THM 4L60-E/4L65-E "UPDATE HANDBOOK"

THM 4L60-E/4L65-E

THM 4L60-E TCC "PWM" SOLENOID ADDED IN 1995 AND NEW OIL PUMP ASSEMBLY FOR 1995

Figure 1

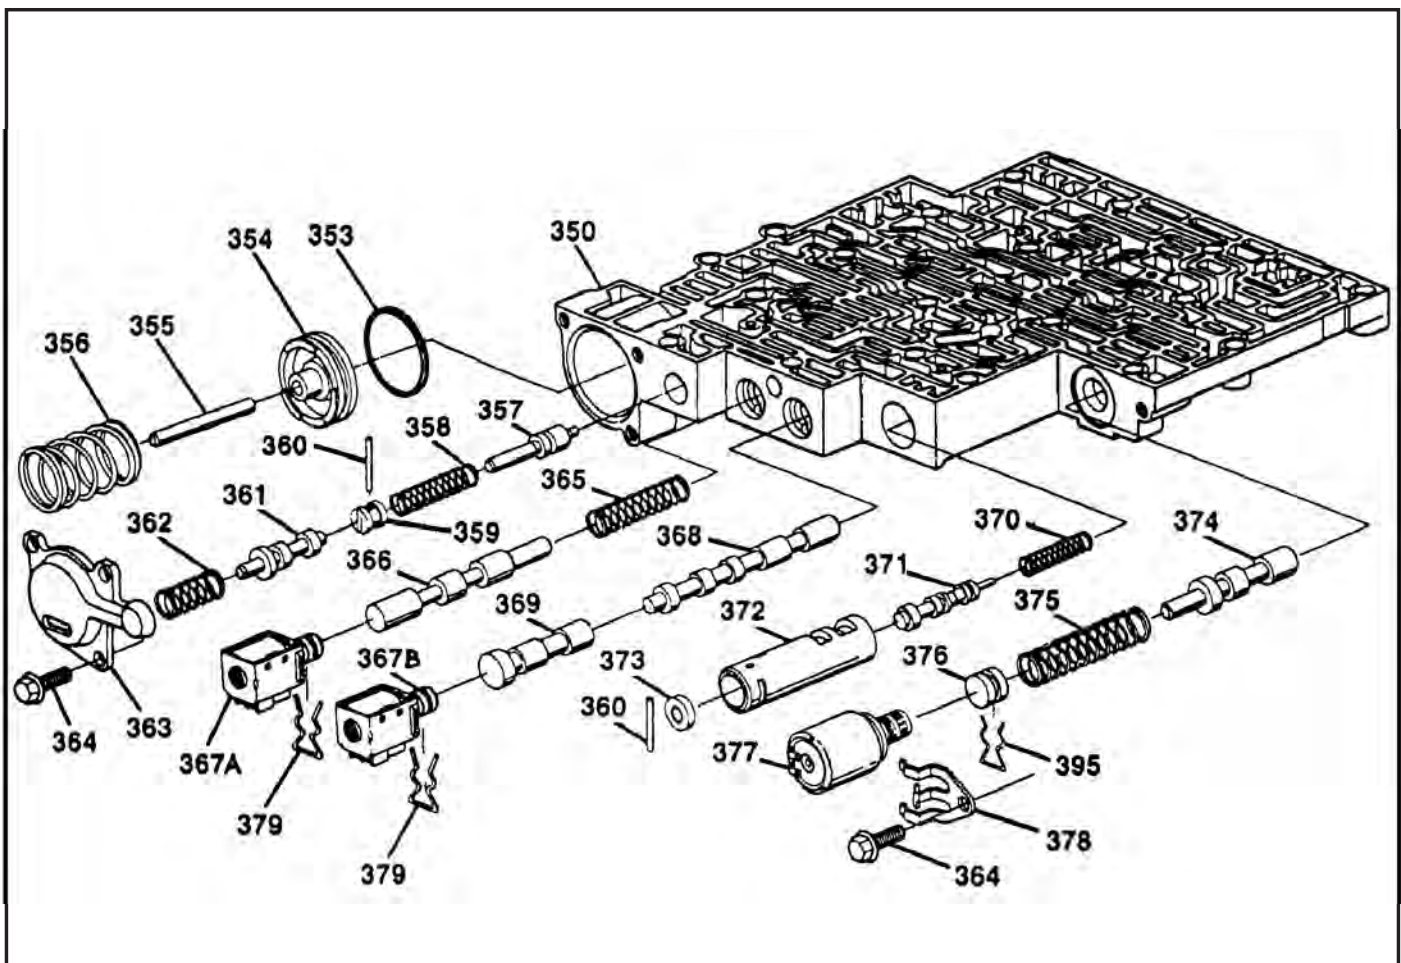
CORRECTION: There is now available a new calibration service package consisting of a 1-2 accumulator valve, valve spring, and 1-2 accumulator valve bushing for the valve body. These are items 370, 371, and 372, as shown in Figure 1 below. This new service package is available under OEM part number 24202698.

Figure 1

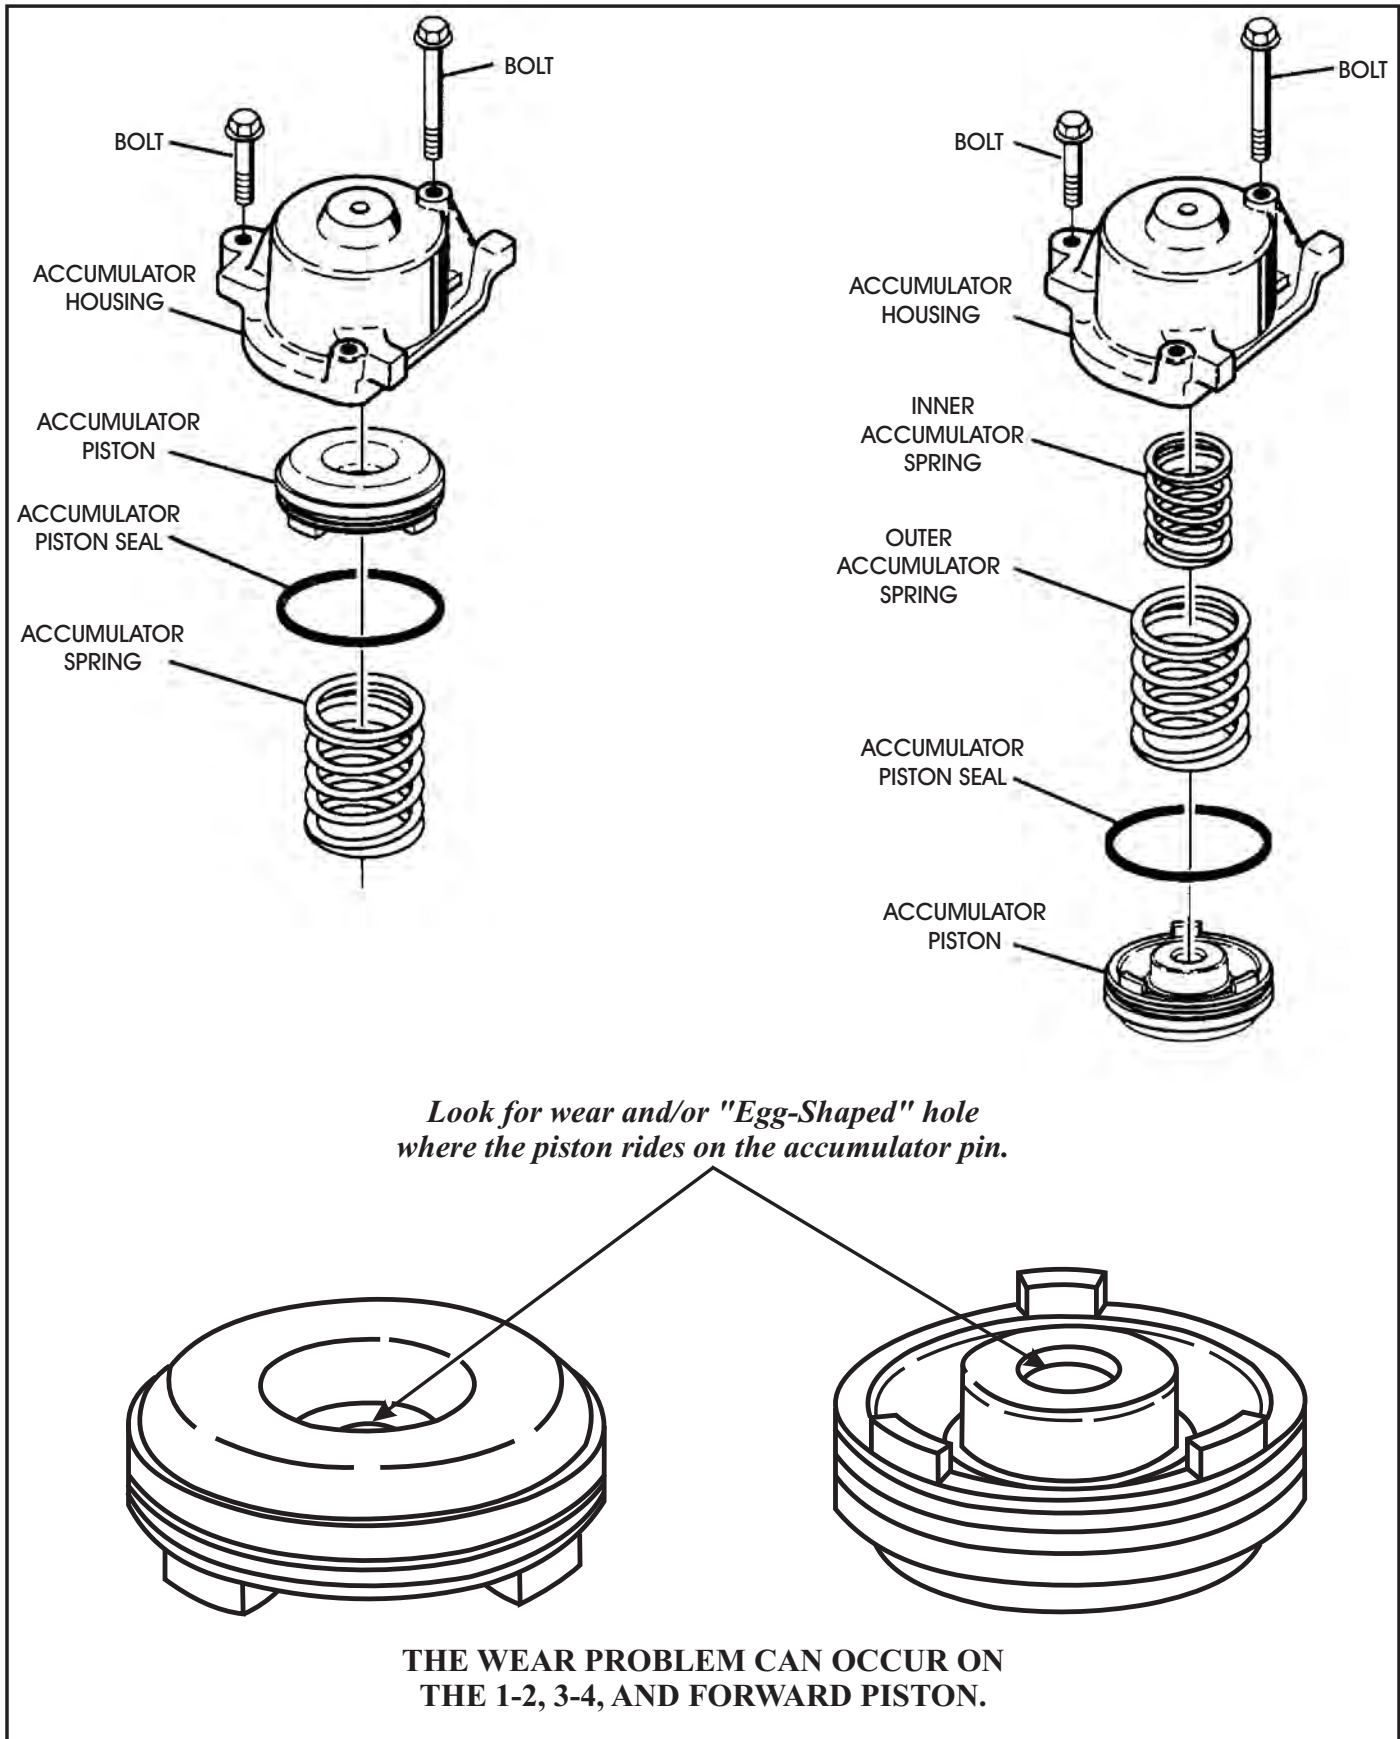
CAUSE: The cause may be, a worn accumulator piston pin bore (See Figure 1).

CORRECTION: Replace the accumulator piston with the proper part number from "Service Information" as shown below.

Figure 1

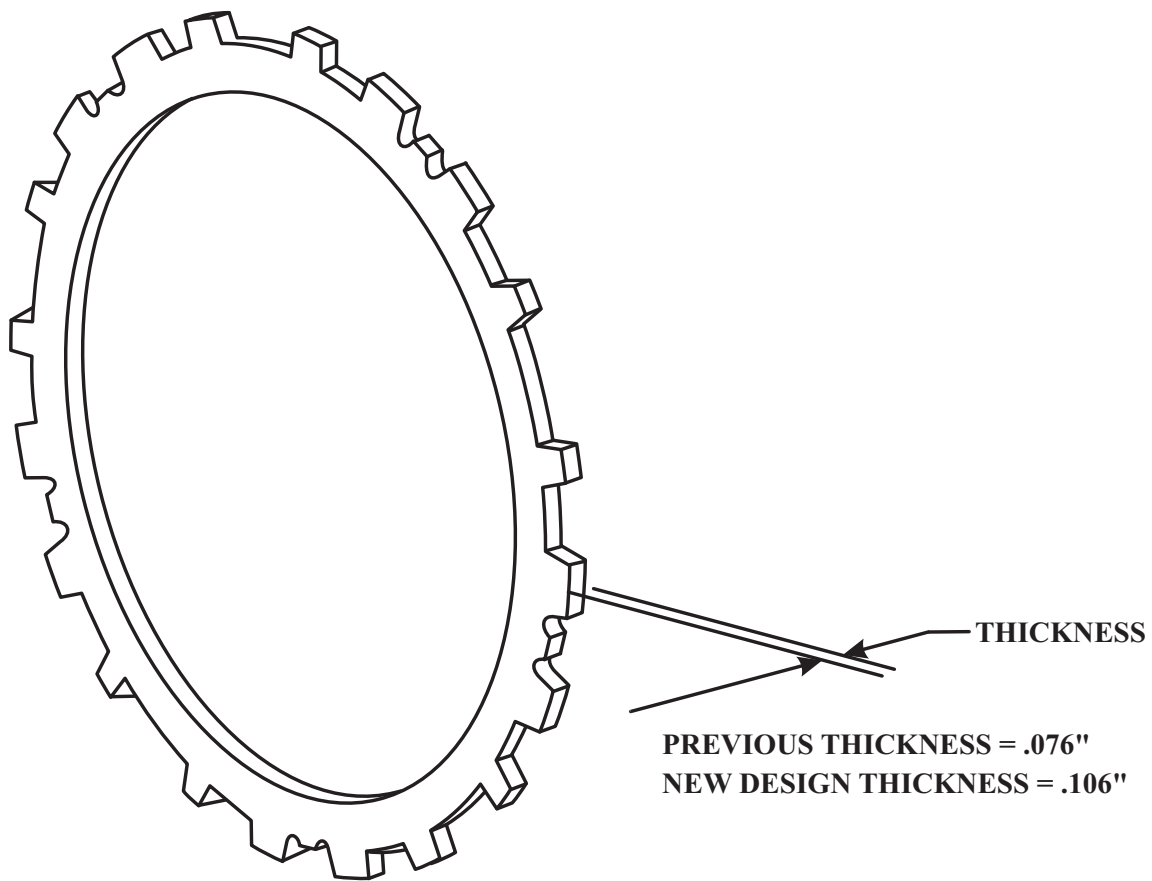
1. New design 3-4 Apply Ring with shorter legs.
2. New design one piece 3-4 Apply Plate.
3. New Design .106" thick 3-4 Steel Plates, 5 required (See Figure 1).
4. New design high energy 3-4 Friction Plates, 6 required (See Figure 1).
5. New design 3-4 Selective Backing Plate, as they are thinner.
6. Re-install the 3-4 Load Release Springs in the late design stack-up (See Figure 2).
7. Ensure that you have .050"-.070" clutch clearance.

Figure 1

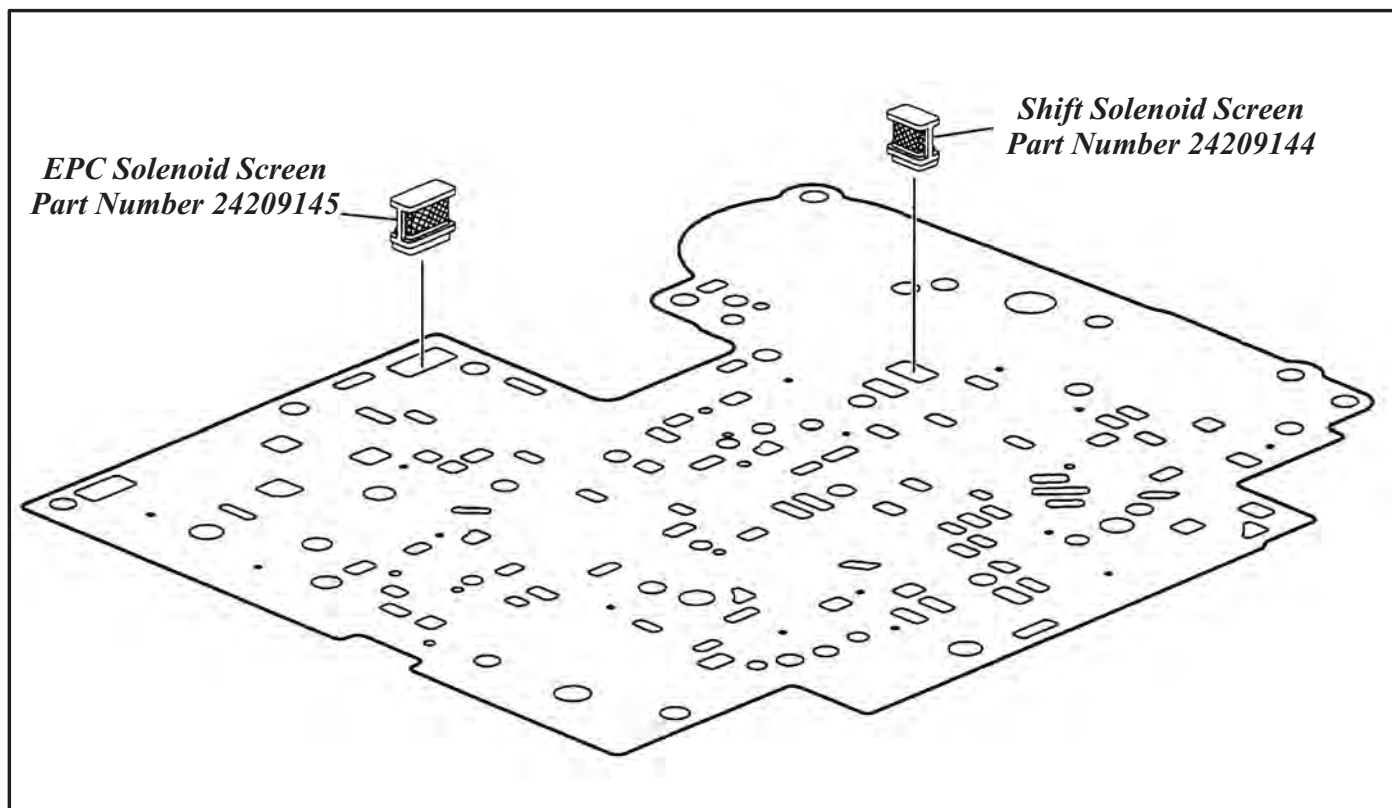
CORRECTION: Replace both screens in the spacer plate as shown in Figure 1, with the part numbers listed below. These *new part numbers* are screens with a larger micron screen that will pass more oil easier.

Figure 1

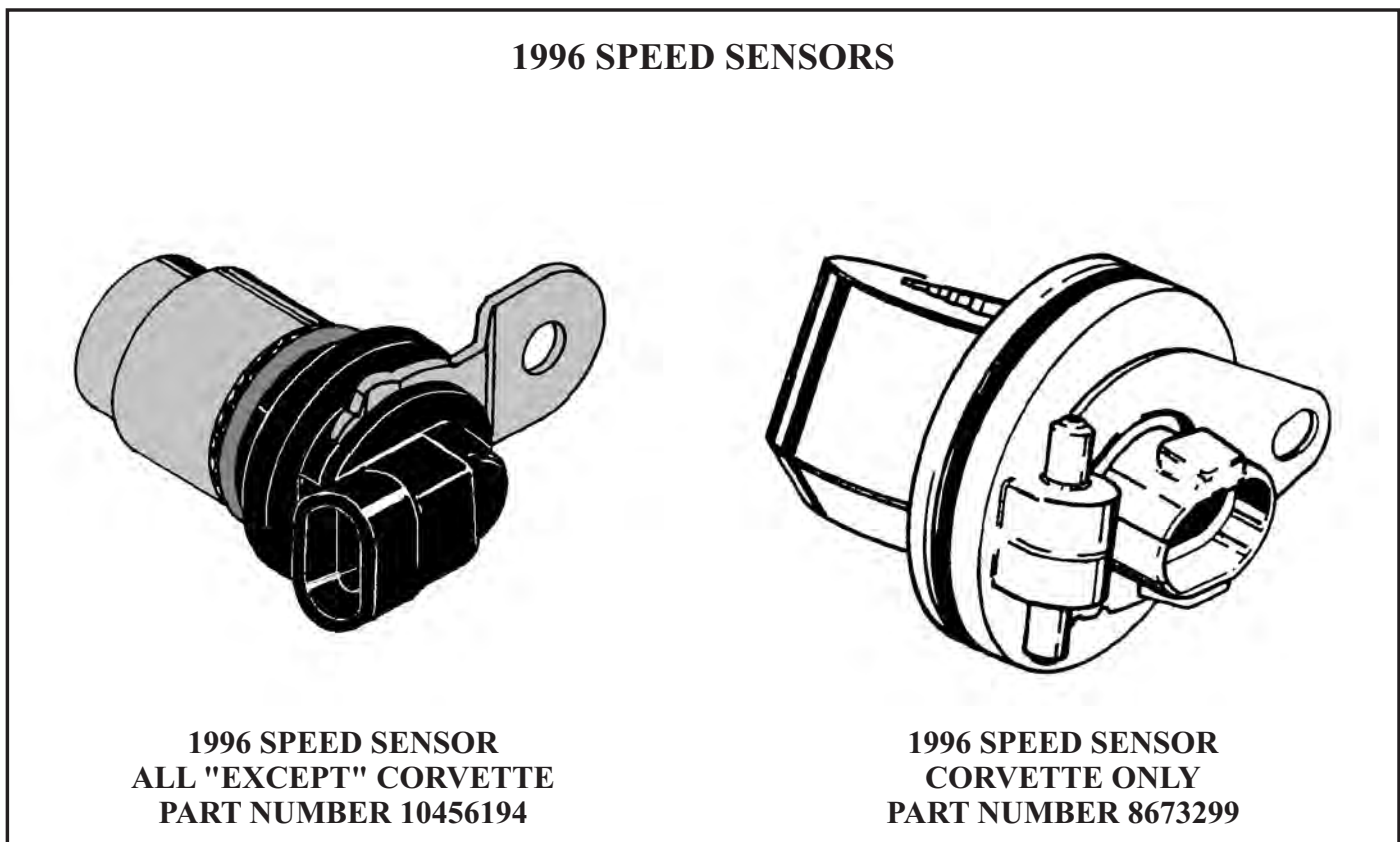
CHANGE: Beginning at the start of production for 1996 models, some THM 4L60-E transmissions were built with a new design Output Shaft Speed Sensor, as shown in Figure 1. Corvette models will be the only vehicle that will continue to use the previous design speed sensor, as shown in Figure 1.

- (1) EXTENSION HOUSING - New casting with smaller speed sensor bore diameter, to accept the new design Output Shaft Speed Sensor, as shown in Figure 1.

Figure 1

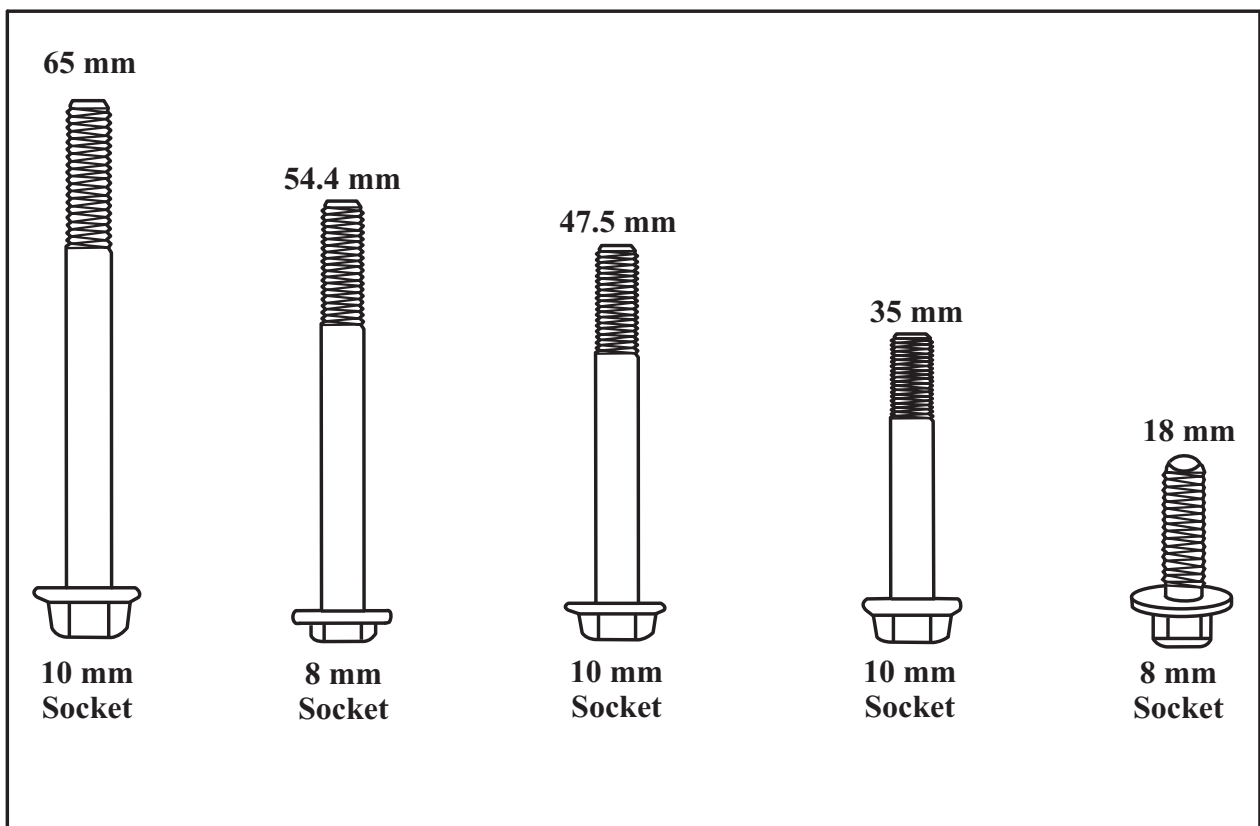
CAUSE: There are different length valve body bolts which can be easily mis-positioned (See Figure 1). A *common* error is placing a 54.4 millimeter length bolt into a location designed for a 47.5 millimeter length bolt (See Figure 2). The mis-located bolt will extend into the barrel of the case and into the sun shell. The bolt now being screwed into the sun shell inhibits the rotation of the shell causing the above complaint.

CORRECTION: Relocate the necessary valve body bolts to their proper location. Use figure 3 to locate the proper positions for the 47.5 and 54.4 millimeter bolt lengths. In severe cases, it may be necessary to remove the transmission in order to replace the damaged sun shell.

Figure 3

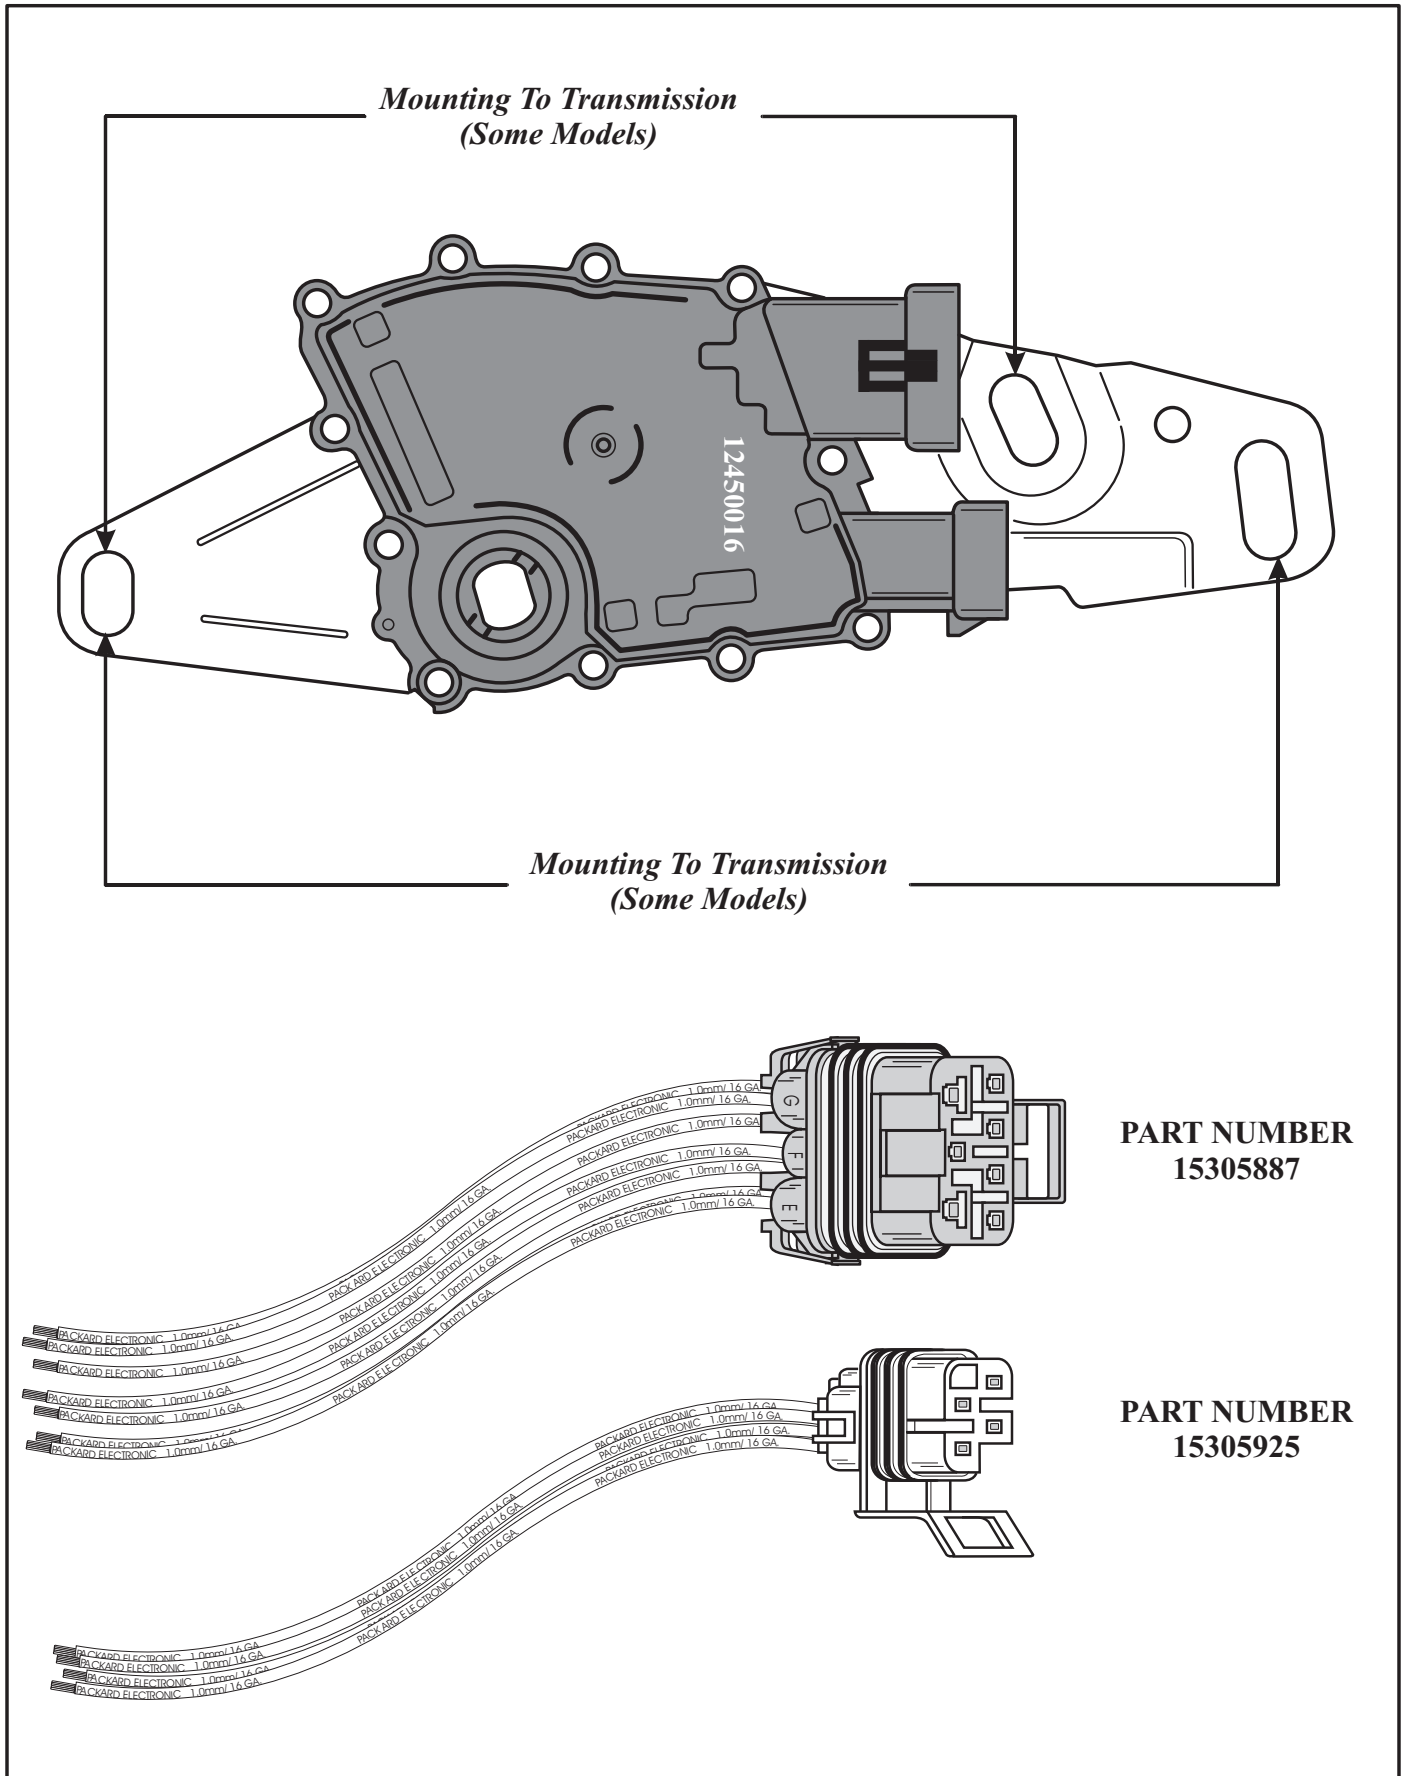
CORRECTION: If the switch is being removed as part of transmission service, *and there are no switch related concerns*, the switch can be removed without removing the connectors, and left hanging until time to be re-installed. However, some models have a mounting bolt directly behind the switch connectors, which requires removing the connectors, and the switch *will be damaged* in the process (See Figure 3).

There is now available from OEM sources, service repair connectors for both the 7-way and the 4-way connectors under part numbers 15305887 and 15305925 (See Figure 3).
